PLANNING AND ZONING COMMISSION

MONDAY, APRIL 24, 2017 – 7:00 P.M.

2. Consider and act on the site plan for Corinth First Baptist Church on property legally described as First Baptist Church Addition Block A, Lot 1 zoned SF-4 Single Family Residential in the City of Corinth, Denton County, Texas and having a physical address of 3033 Meadowview Drive.

Resubmittal: First Baptist Church, SP review Lot 1, Block A, First Baptist Church Addn

SITE PLAN
FIRST BAPTIST CHURCH CORINTH

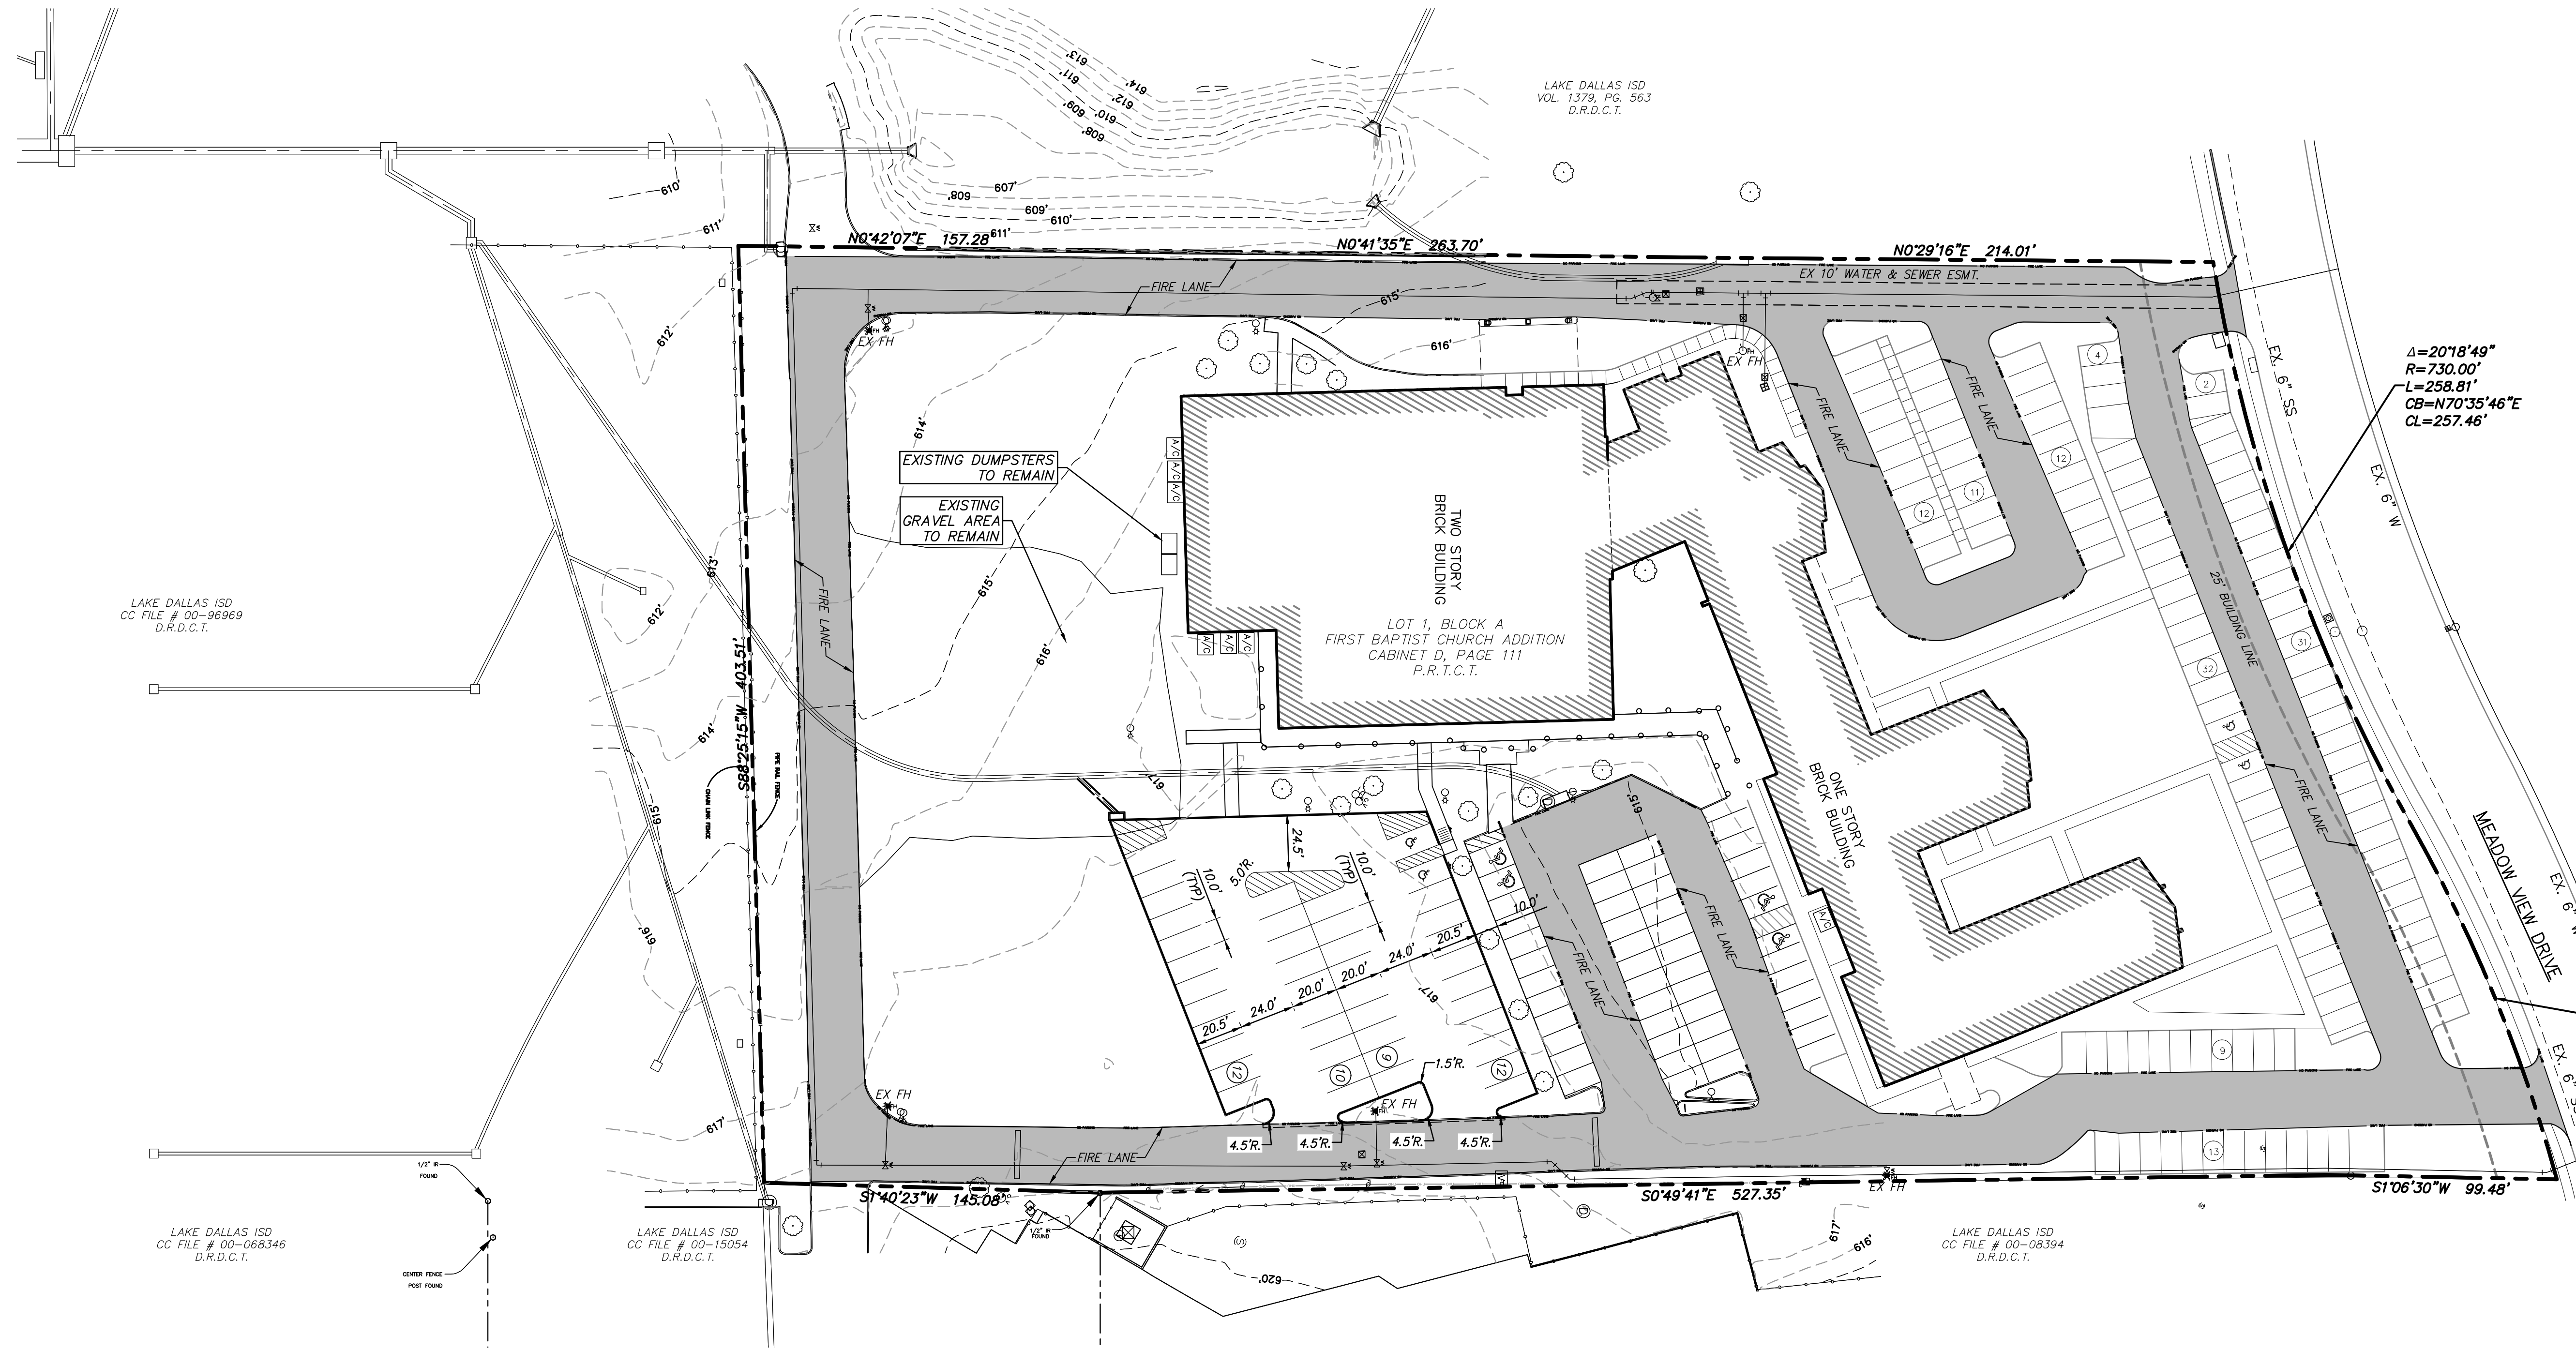
1. **Original Comment #8** - Clarify that the gravel used for parking on the south side of the building will be removed.

Staff: Staff is agreeable to the gravel remaining however please provide an additional note on the site plan stating, “Parking is not permitted on the graveled area.”

Consultant Response: Noted on the plat – “existing gravel area to remain”.
